PLANNING & ZONING COMMISSION

Wednesday, May 18, 2022, 10:00 AM

- B. **Request for Site Plan; Bristol Park Apartments** (Project Name); 19510 US 4541(Site Address) Limit Ave (South) US Hwy 441 (North East) (Location); Cagan Management Group, Inc. (Applicant); Wicks Engineering Services, Inc. (Engineer); L.R. Huffstetler, Inc. (Landscape Architect); Forum Architecture & Interior Design (Architect). Project No. SP22-03.

BRISTOL PARK APARTMENTS
 COVER SHEET
 MOUNT DORA, FLORIDA 34736

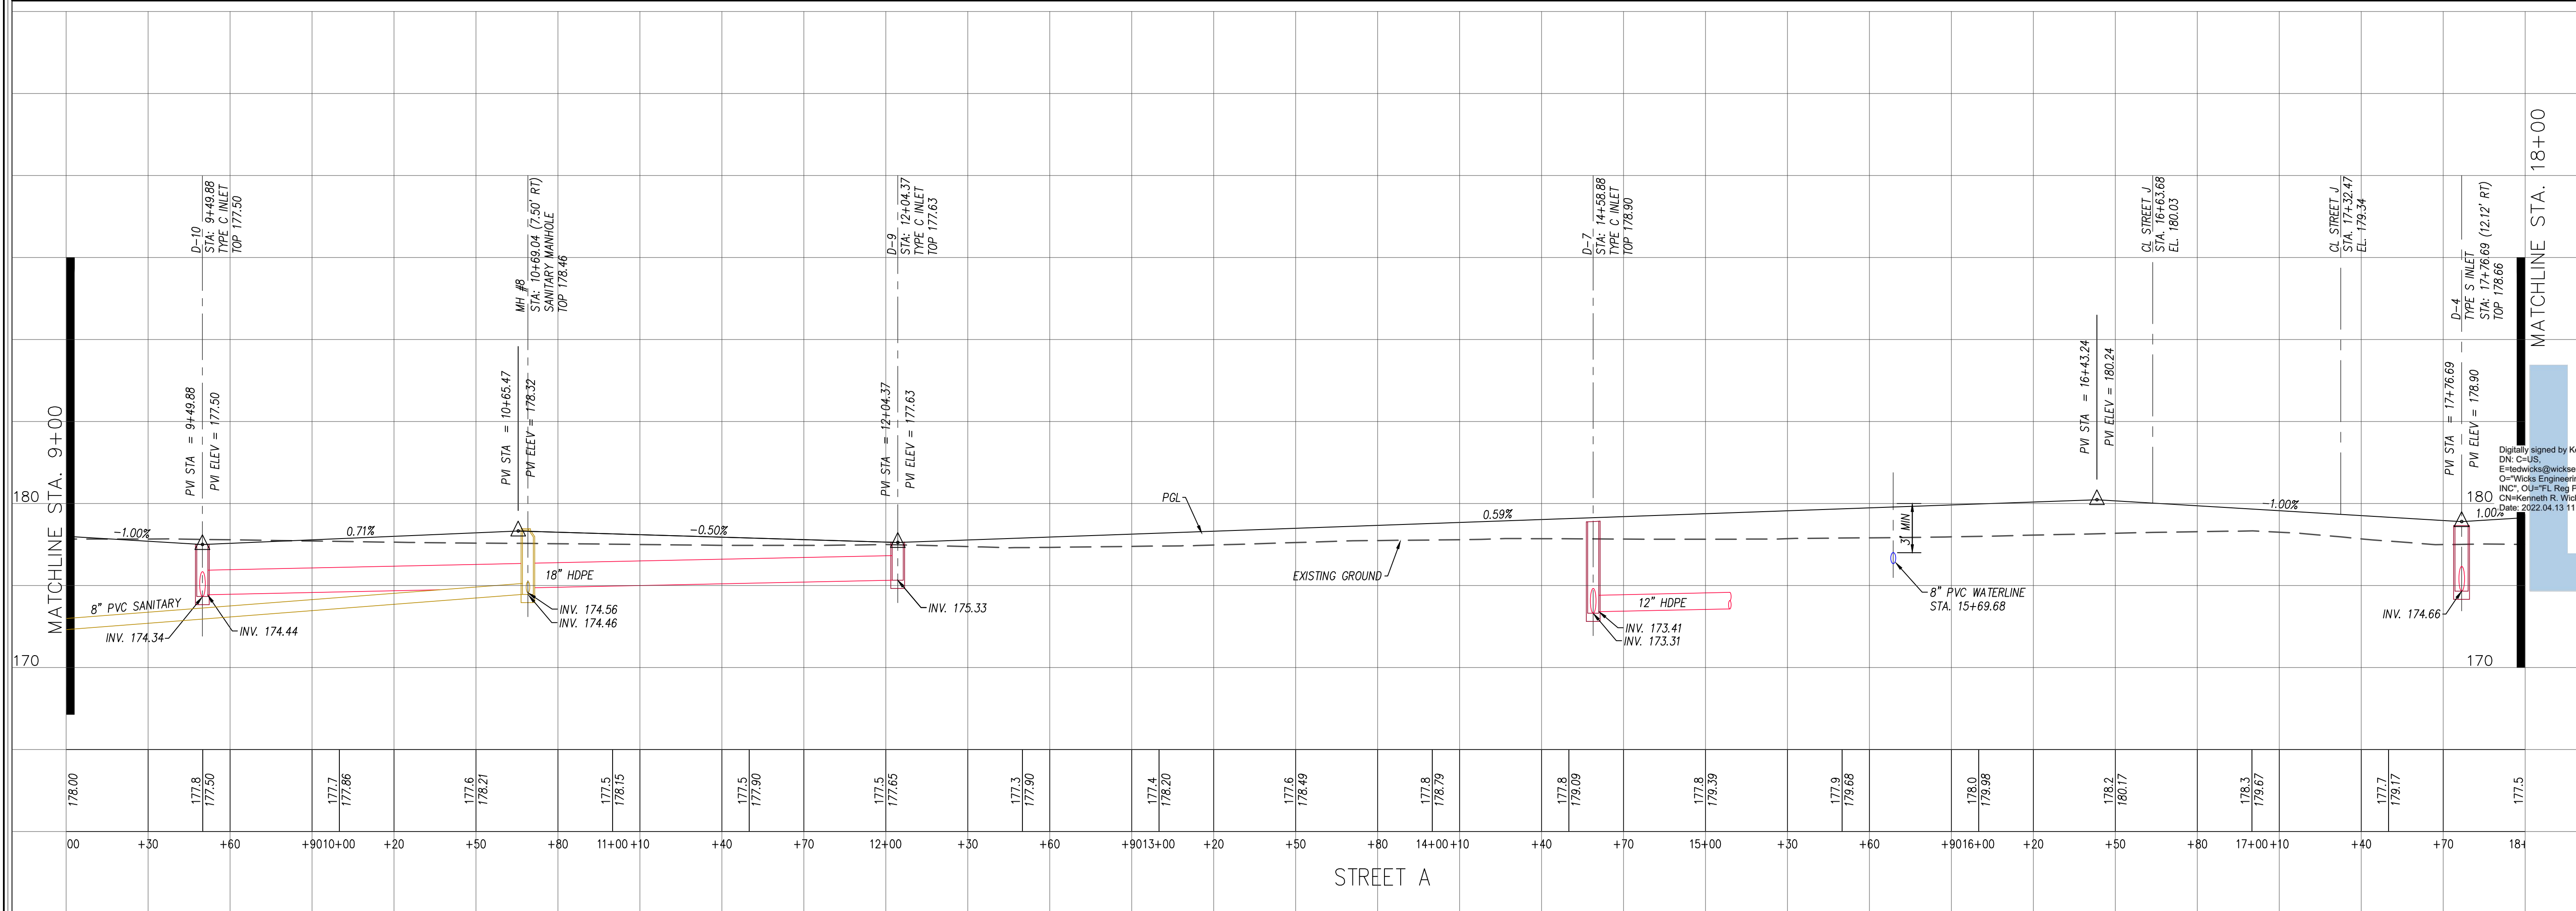
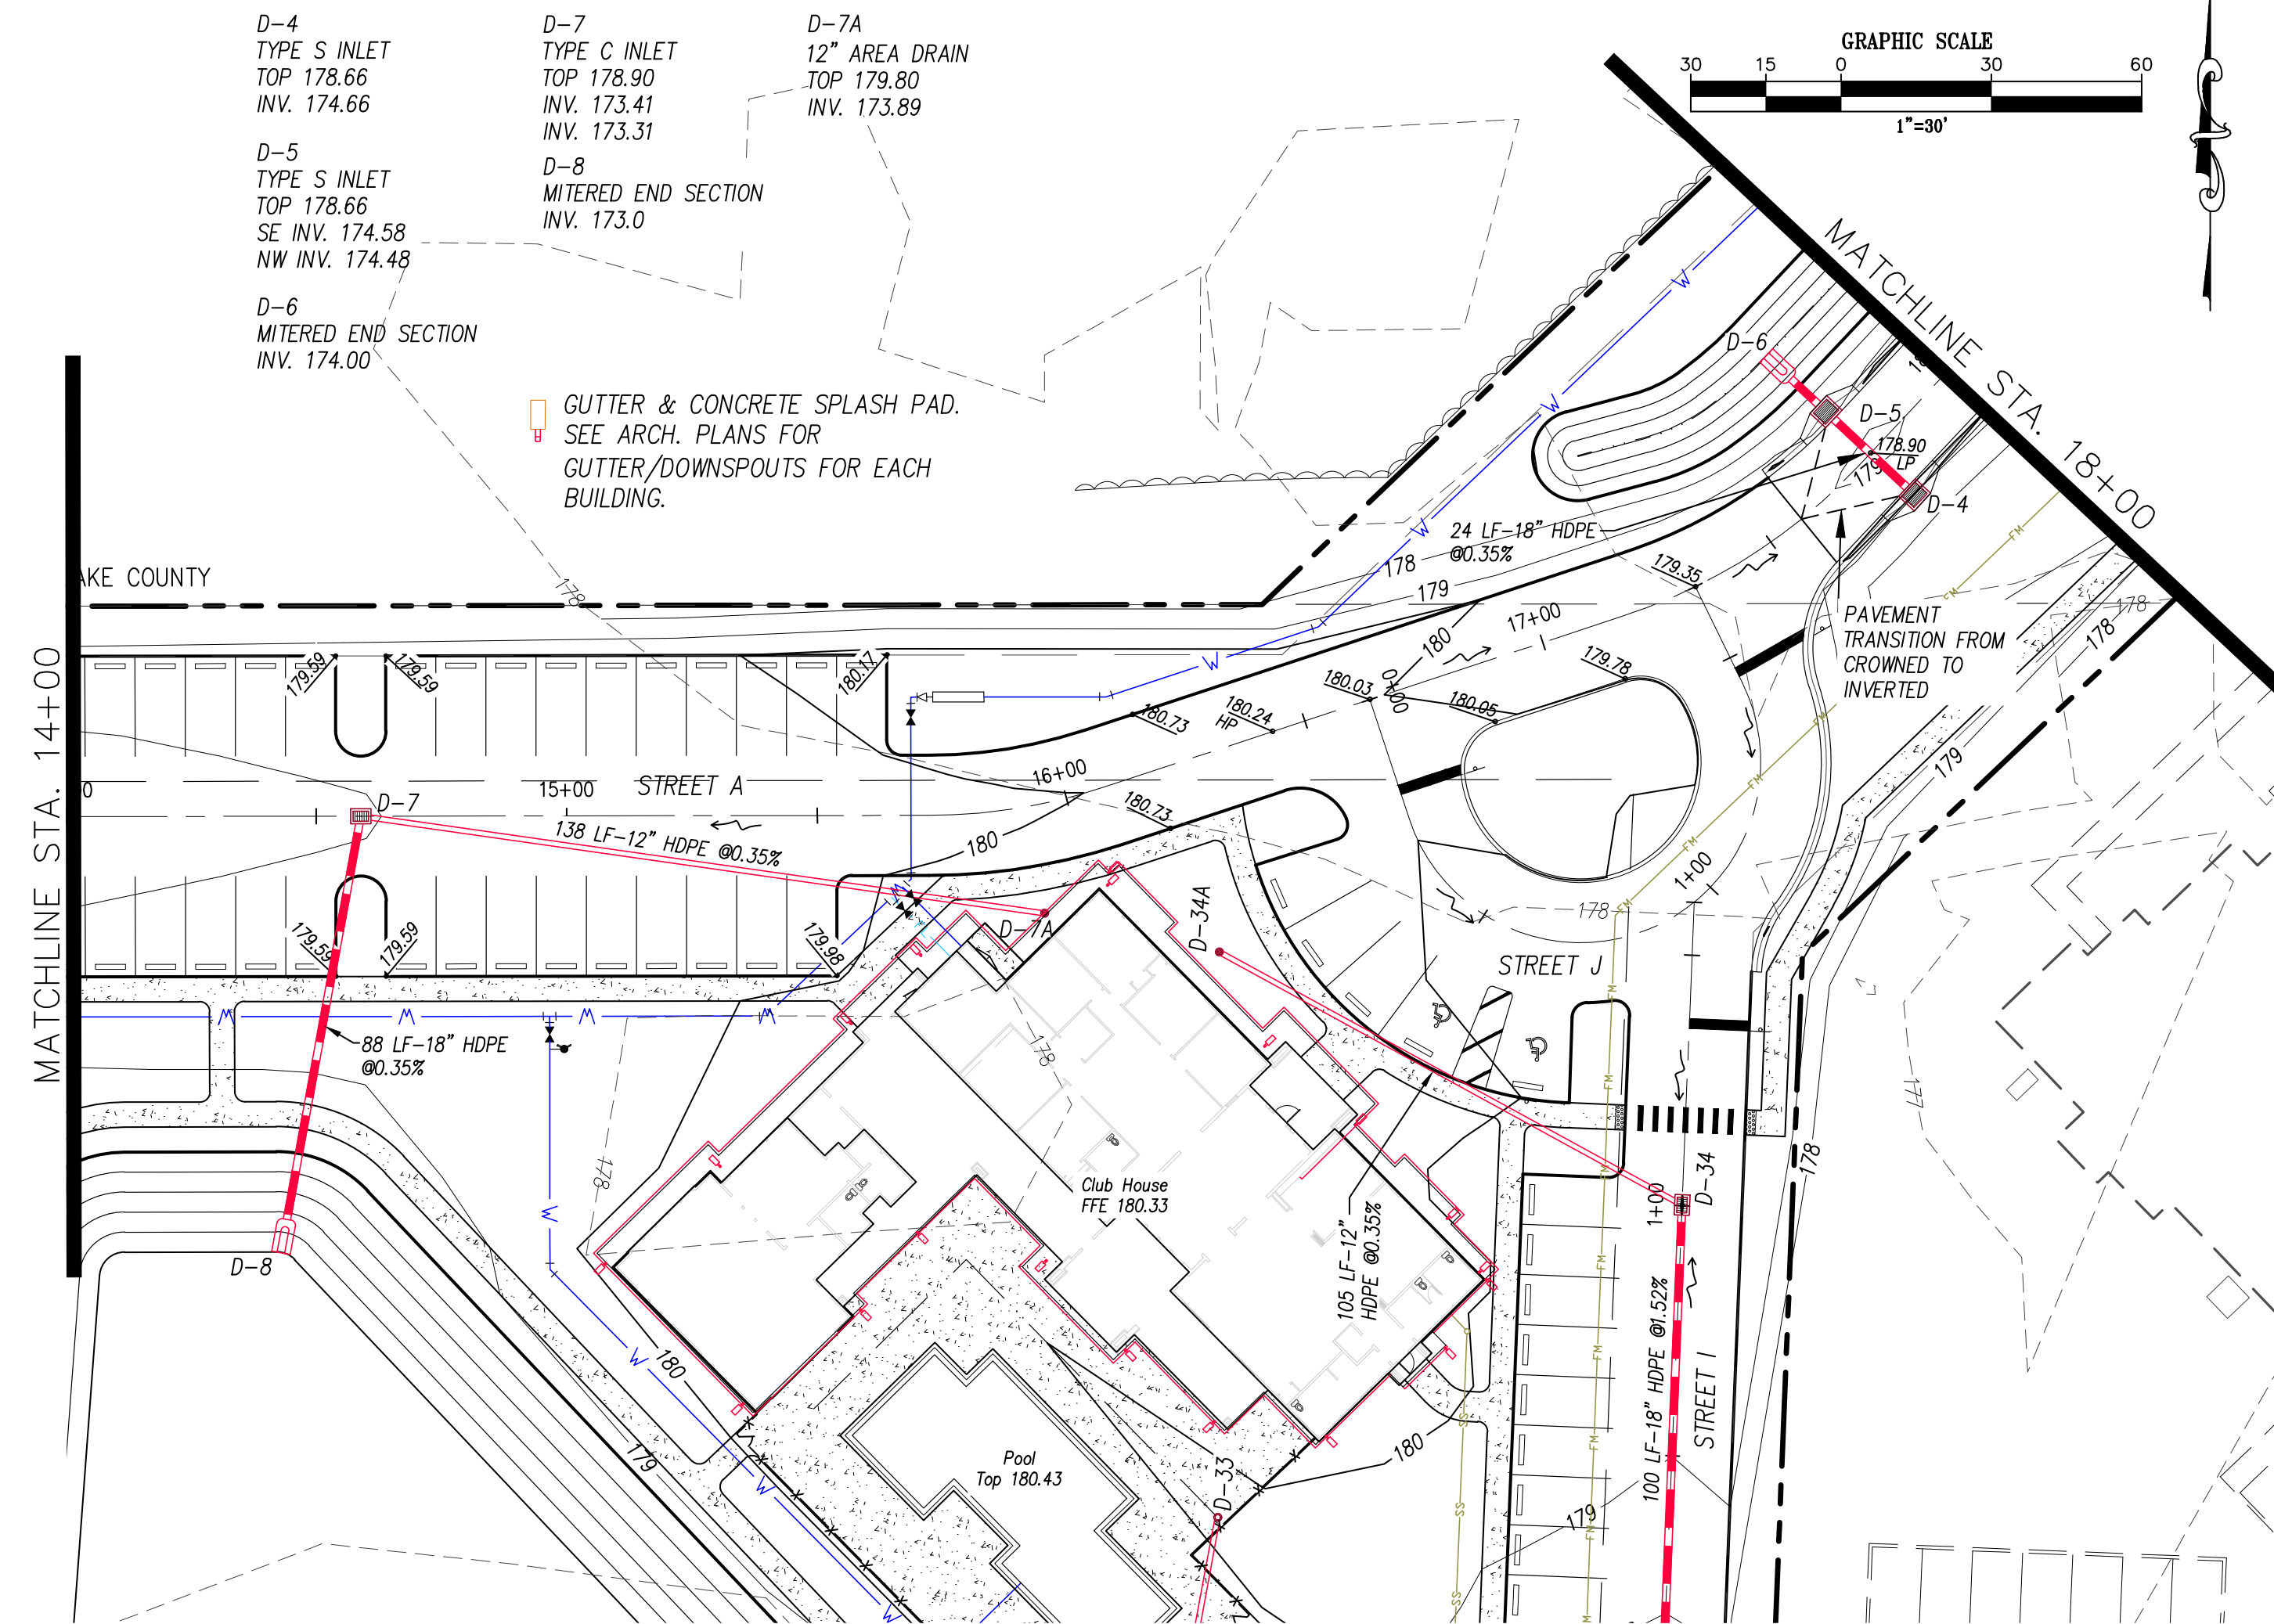
32. Resolved
33. Sheet 10 of 26 – now sheet 12 - storm structure D-9 is only 2.3 feet deep and has an 18-inch pipe connected to it and D-10 is only 3.16 feet deep with an 18-inch pipe connected to it. The storm pipe will be into the base or subbase of the drive aisle. **Repeat comment**
